**US SAFETY DIRECTIVE NUMBER 127**

**MODIFICATION M228**

<b>TITLE</b>	CKT exhaust
<b>CLASSIFICATION</b>	The UK CAA have classified this as Mandatory.
<b>COMPLIANCE</b>	All aircraft, Inspection before further flight. At or before the next annual renewal, fit modification M228 or modified exhaust (exhaust serial number 10940809 onwards)
<b>APPLICABILITY</b>	All Quik, GT450 & QuikR fitted with CKT stainless steel twin exhausts. The CKT exhaust serial number is stamped on one end cover plate.

**Fig 1. Crack location all round weld outer edge**

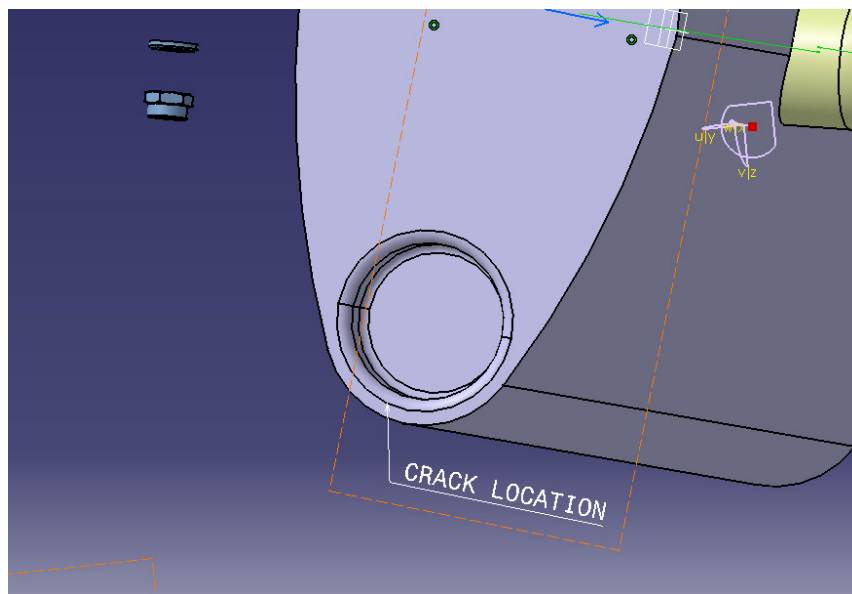
The CKT exhaust silencer has separate front and rear perforated baffle tubes which are welded to the front and rear end cap flanges and plugged with a cap. A fatigue failure of a pair of exhausts serial no. 7811107 has occurred at 125 hours, around the flange edge on the rear end cap, at the weld edge (see fig 1). The baffle tube came free and was ejected from the silencer and hit the propeller. Fortunately this happened at low power on approach, propeller damage was localised and the baffle tube missed the sail; under high power the consequences could be very serious.

Before further flight, using good light and a magnifying glass, closely inspect the area around all 4 silencer end caps for cracks, particularly on the weld edges (see fig 1). If cracks are noted, contact P&M Aviation, if possible by email attaching pictures of the damage, hours run, aircraft and exhaust serial numbers. The aircraft must not be flown with cracks in this area.

**Fig 2. Movement of inner baffle plate.**

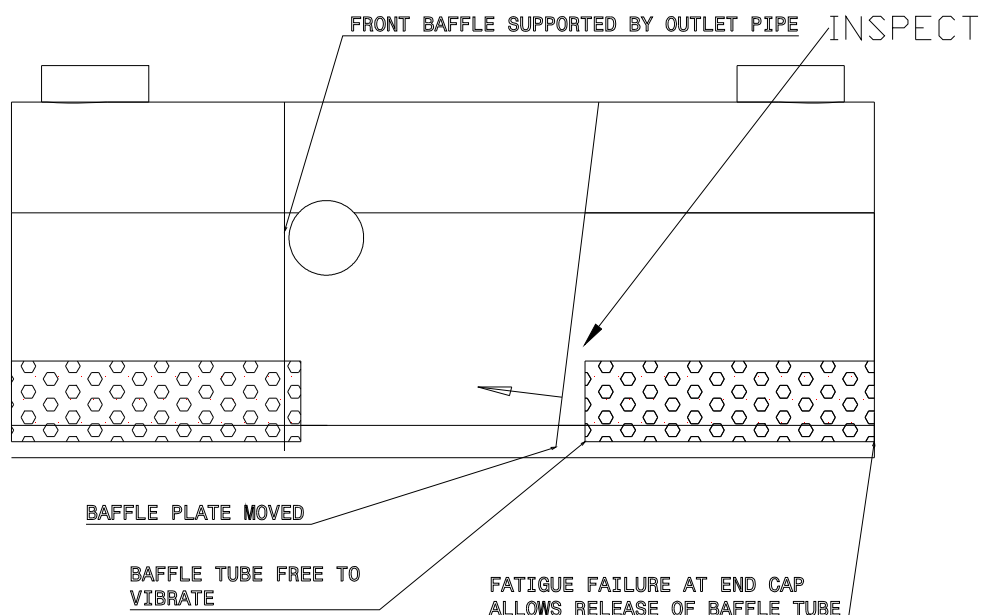
See fig. 2. Through the exhaust header pipe holes, using a torch and mirror, inspect the welded connection between the internal baffle plate and the end of the perforated baffle tube. Try pushing the bottom of the internal baffle plate inwards. If the baffle plate has moved inwards towards the centre of the exhaust and the baffle tube has disengaged from the baffle plate, ***the exhaust must be replaced***. Disengagement is more likely on the rear internal baffle, as the front internal baffle is supported by the outlet pipe.

**Fig 3 Exhaust Keeper modification M228**

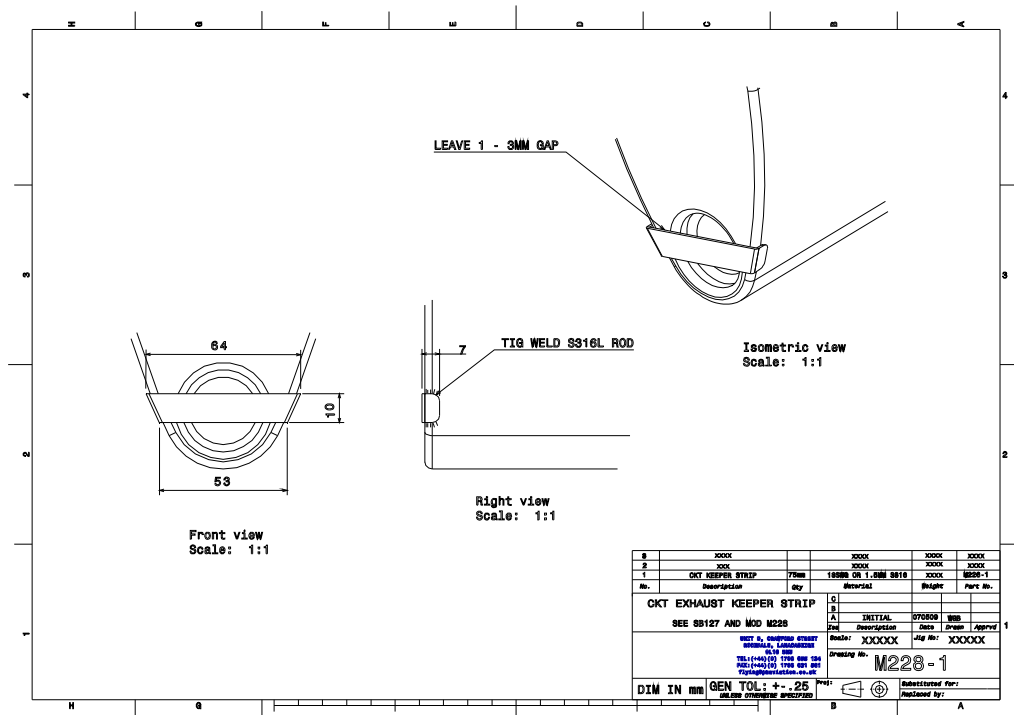
The problem has been solved by welding on back-keeper plates (modification M228), or by fitting new modified exhausts which have smooth end caps with no baffle tube features.

If the inner ends of the baffle tubes and internal baffles are secure, modification M228 can be carried out (see fig. 3). It provides a backup retainer if the baffle should become loose. Thoroughly clean the area. Do not use any dissimilar wire brush metals and do not mark with graphite or carbon pencils. Weld repair any cracks found using a stainless steel 316L welding rod and TIG process. Fit a 10mm wide x 18swg ( 1.22mm) or 1.5mm S316 strip with 7mm bent edges as shown, weld to the silencer ONLY at the corners, over the existing corner weld. The repair/modification must be carried out by a welder qualified for thin (0.9mm) stainless steel. FAA publication AC43-13-1B is a useful guide to procedures.
